Service Bulletin

Product Family: 915 Series Ariens Zoom XL and Gravely ZTXL

Subject: Parking Brake Link Bending

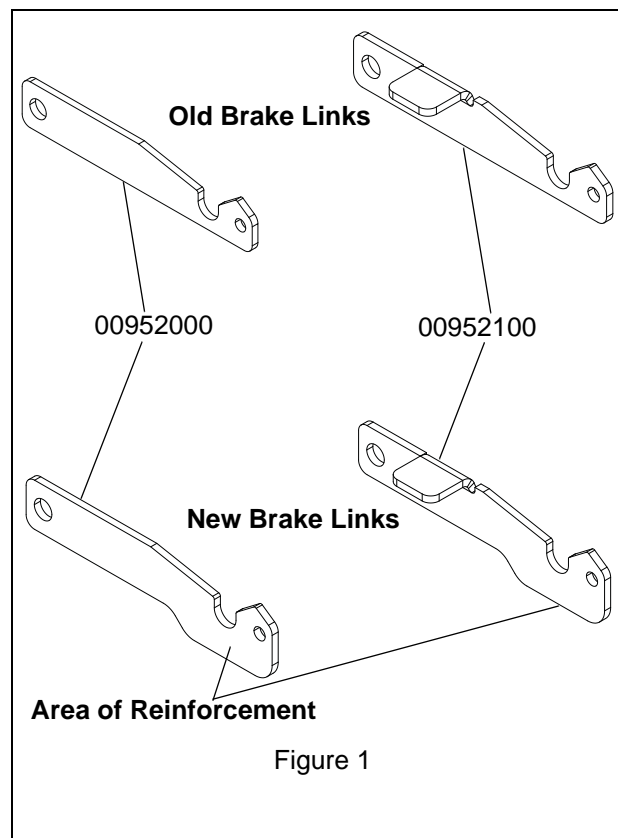
Ariens Company has recently strengthened Brake Interlock Link 00952100 and Brake Interlock 00952000 (replaced by kit # 51522100) to prevent possible bending which causes the parking brake to be difficult or impossible to engage (Figure 1).

Dealers should install the new 51522100 Brake Link Kit on unsold inventory prior to sale. Additionally, all machines in process for additional repairs should be updated with a new 51522100 Brake Link Kit.
